Access Compliance Report

Public Rights-of-Way

(Curb Ramps)

Intersection ID: 11054	Main Street: DOWNS_AV	Cross Street: NEWELL_AV	Location:	E
ADA ID: 55E684158A85	Ramp Type: Perp	Initial Pass/Fail: Fail	Overall Compliance: No	Severity Score: 25
Codes/Mitigation Info/Possible Solution		Field Measurements/Component Compliance

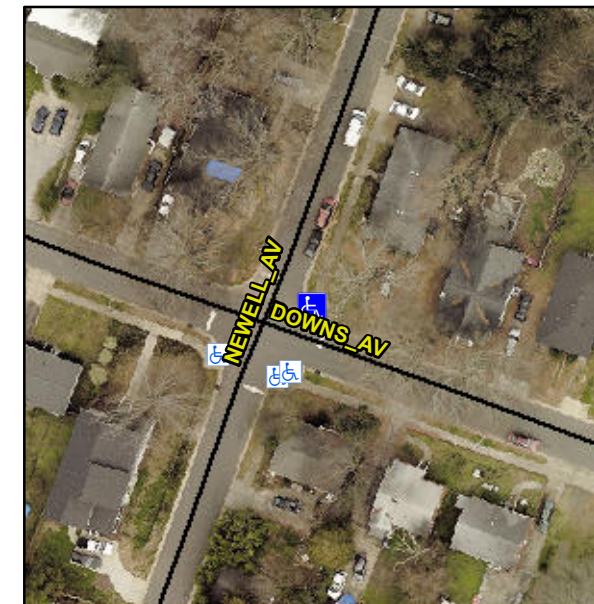
Not Found, R304.5.3

Compliance	Description	Data	Compliance	Description	Data
N/A	Ramp Length (in)	48.0	Yes	Ramp Slope (%)	5.4
Yes	Ramp Width (in)	48.0	No	Ramp XSlope (%)	7.3
N/A	Flare Type LT	N/A	N/A	Flare Type RT	N/A
N/A	Flare Slope LT (%)	N/A	N/A	Flare Slope RT (%)	N/A
N/A	Flare Traversable LT?	N/A	N/A	Flare Traversable RT?	N/A
N/A	Landing Length (in)	N/A	N/A	DWS Provided?	N/A
N/A	Landing Width (in)	N/A	N/A	DWS Contrast?	N/A
N/A	Landing Slope (%)	N/A	N/A	DWS Length (in)	N/A
N/A	Landing X Slope (%)	N/A	N/A	DWS Full Width?	N/A
N/A	Landing Curb? (Y/N)	N/A	N/A	DWS Offset (in)	N/A
N/A	Shared Landing?	N/A			
N/A	Gutter Ponding?	N/A	N/A	Gutter Slope (%)	N/A
N/A	Gutter Lip Ht (in)	N/A	N/A	Gutter X Slope (%)	N/A
N/A	Painted X Walk1?	No	N/A	Painted X Walk2?	N/A
	X Walk 1 Direction	To SW		X Walk 2 Direction	N/A
N/A	X Walk 1 Width (in)	N/A	N/A	X Walk 2 Width (in)	N/A
	X Walk 1 Slope (%)	1.6		X Walk 2 Slope (%)	N/A
	X Walk 1 X Slope (%)	5.2		X Walk 2 X Slope (%)	N/A

Remove & Replace Entire Ramp.
